Environmental Review Team Report

Chittenden Hill Estates

Clinton, Connecticut

January 1984

Drainage Areas

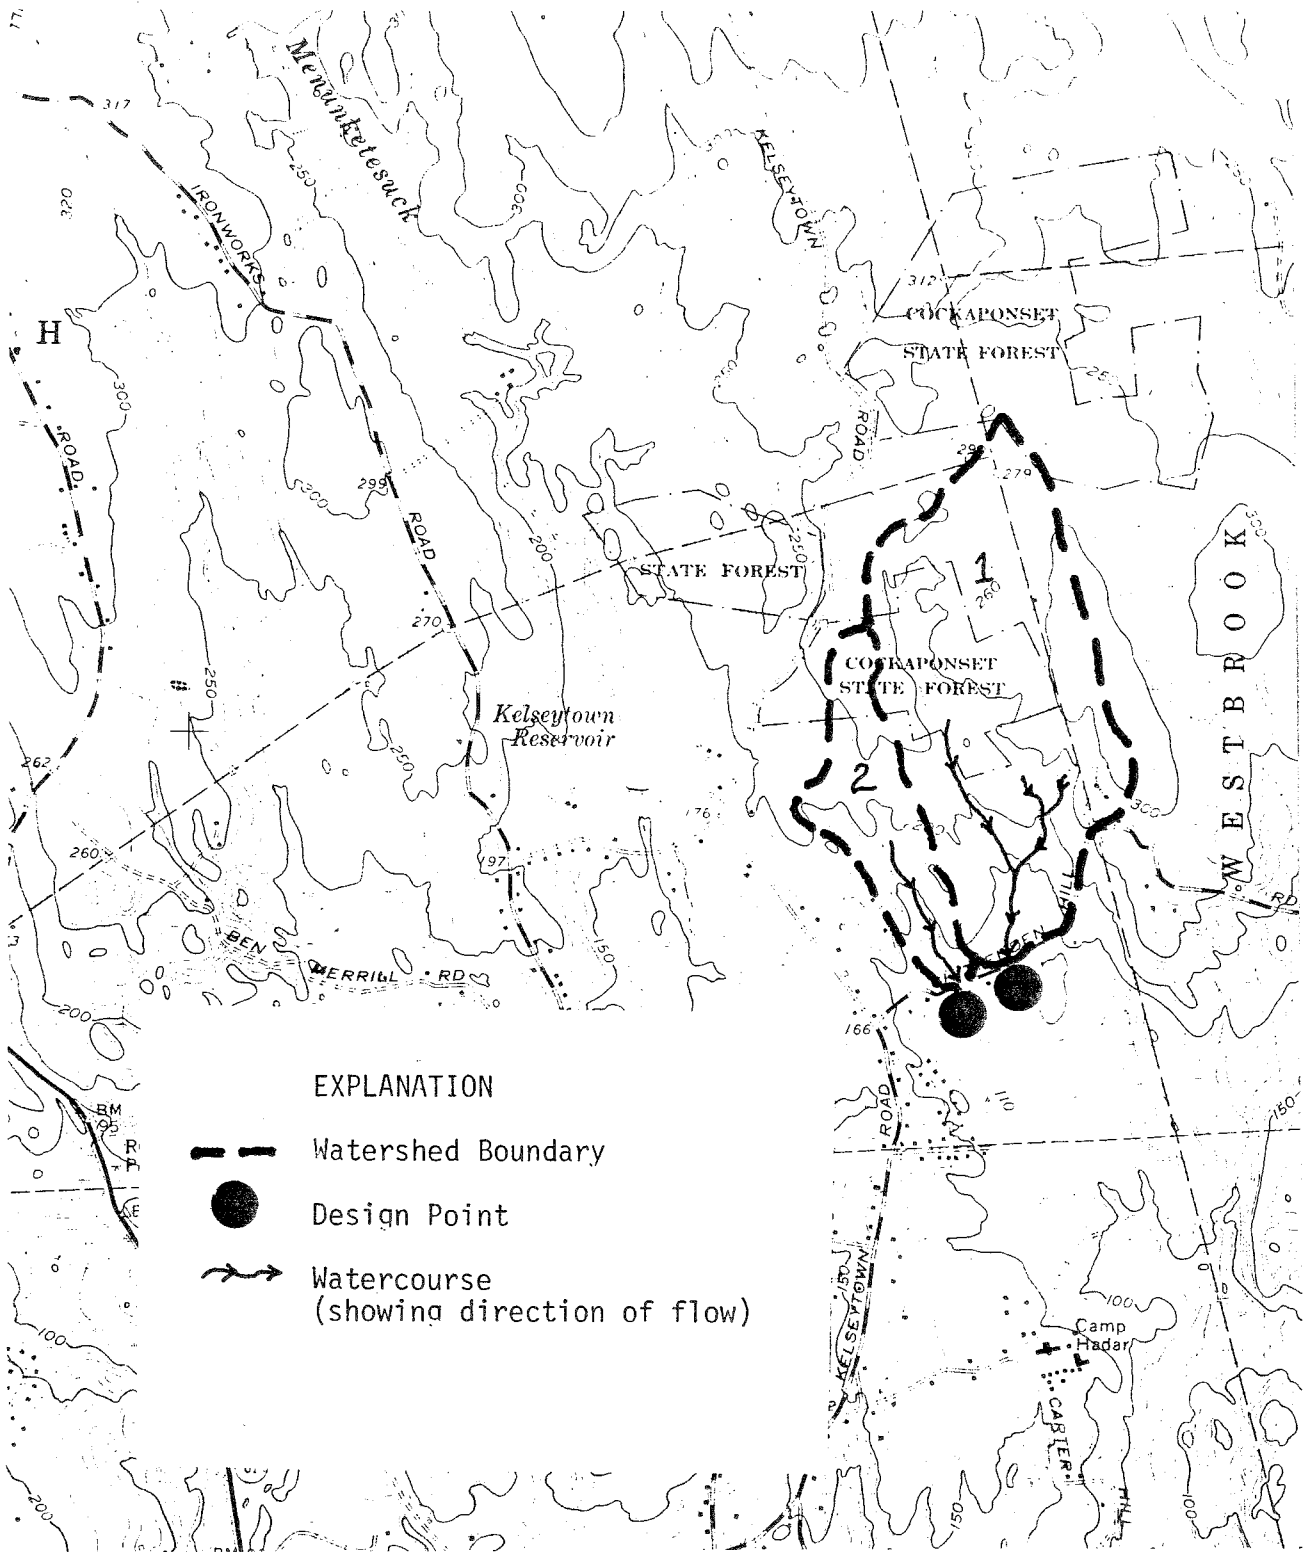
The drainage pattern of the Chittenden Hill Estates site was described in the initial ERT report (October, 1978). It does not appear as though the watershed has been altered since the initial review. An accompanying illustration delineates the approximate drainage area for the watersheds draining the two intermittent streams on the site. According to town officials, flooding problems have been reported at the culvert under Chittenden Hill Road, which drains watershed I (see Drainage Area Map), particularly during the springtime. As a result, they are concerned about the potential aggravation of the flooding problem by the proposed development in this area. It should be noted that Town officials did not indicate to Team members whether or not flooding occurs at the culvert draining watershed II.

As mentioned earlier, the town is concerned that an existing flooding problem at the culvert draining watershed I under Chittenden Hill Road would be further aggravated by the proposed subdivision. Based on the runoff calculations computed by the Team Geologist, it appears the existing 12 inch corrugated metal pipe is probably too small to handle the flow from a 10 year storm under present conditions. (A 10 year storm is a storm that would be expected to occur once every ten years. In any given year, a 10 year storm would have a 10 percent chance of occurring.) This may be a main reason for the flooding problems mentioned by town officials that occur at the culvert under Chittenden Hill Road, which drains watershed I. Since the increase in post development runoff from the site will be slight, it appears that the proposed subdivision should not significantly aggravate the flooding problem at the culvert under Chittenden Hill Road. However, it is recommended that the Town Engineer direct attention to these problems so that the necessary corrective measures can be implemented.

Lots 9 and 10

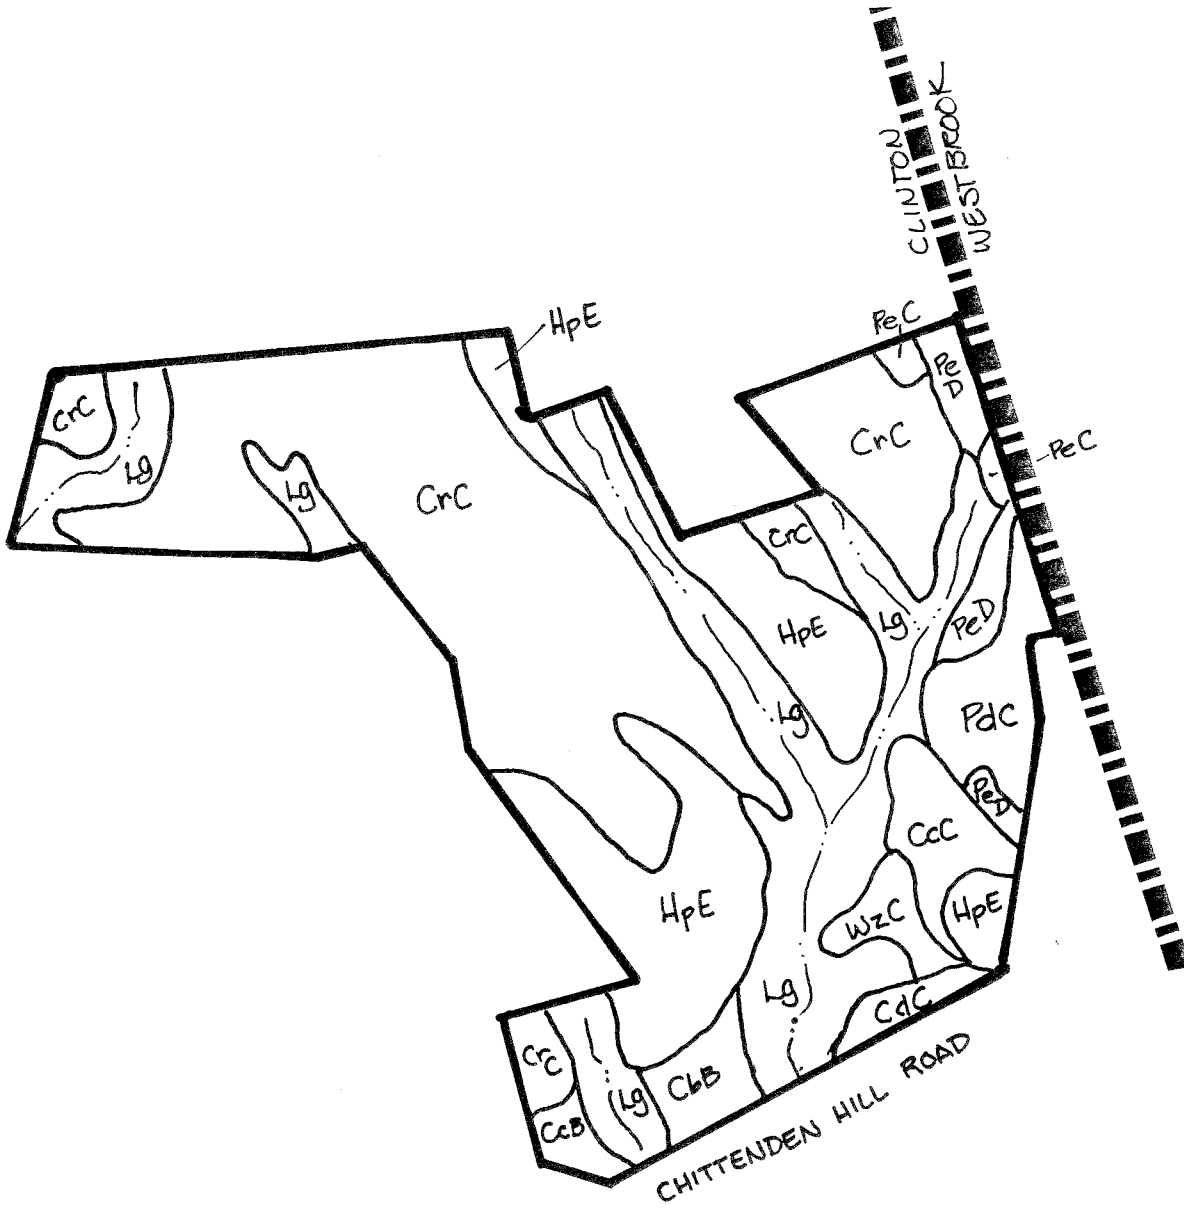
The curving nature of the road in front of lots 9 and 10 will make it difficult to locate driveways that will have safe sight lines. The road in front of these two lots also has very poor storm drainage giving rise to the possibility of road icing in the winter and wet slippery roads during warmer weather. The combination of poor sight lines and slippery road conditions in front of these two lots could cause dangerous driveway access to Chittenden Hill Road. The Town should assure that these two lots are developed in a manner that minimizes this danger. It might help to put a notation of this on the subdivision plan as a reminder of these problems.
